2 March 2020

Ms Sifa KC
Senior Town Planner
Cumberland Council

DA/2019/141/1 - PROPOSED RESIDENTIAL FLAT BUILDING AT 11 – 17 JOYNER STREET, WESTMEAD

Figure 1: 3D Height plane illustrating extent of height departure

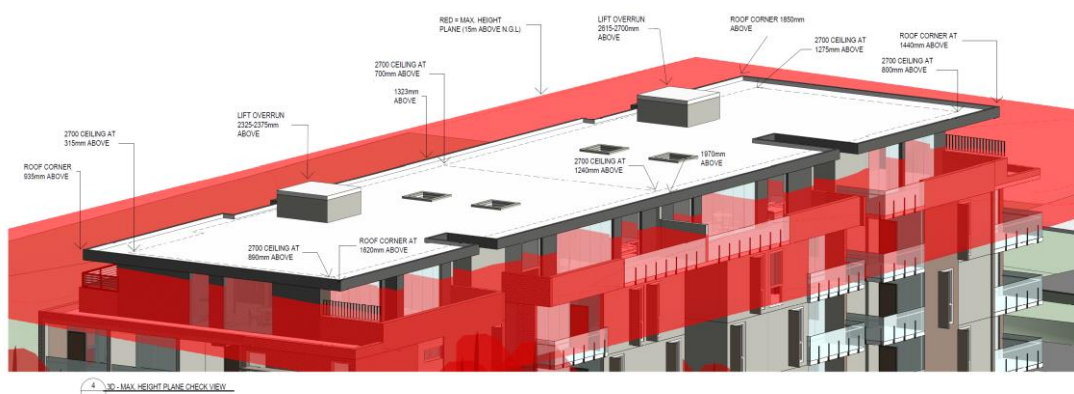
Deferral reason B requests that Council assess the latest clause 4.6 variation noting that heights have been increased.

As illustrated in figure one below, the development will exhibit the following building height elements:

Portion	Maximum Height	Departure
Upper level of residential units (i.e. habitable floor area)	15m	1320mm
Lift Over-runs	15m	2670mm

- Non-compliance is minor in nature with the majority of the building being compliant with the building height control and with the lift overruns recessed, their impact to the streetscape is negligible as it will be visually unnoticeable when viewed from the street level.

- The variation is primarily as result of appropriately responding to the overland flow constraints of the site. Given the extent of development within the catchment, the extent of overland flow is likely to have been reduced through the provision of OSD within these developments. Notwithstanding this, a conservative engineering approach has been adopted, resulting in the building being raised to cater for overland flows. The resultant development is consistent with the 5 storey development envisioned for the precinct;
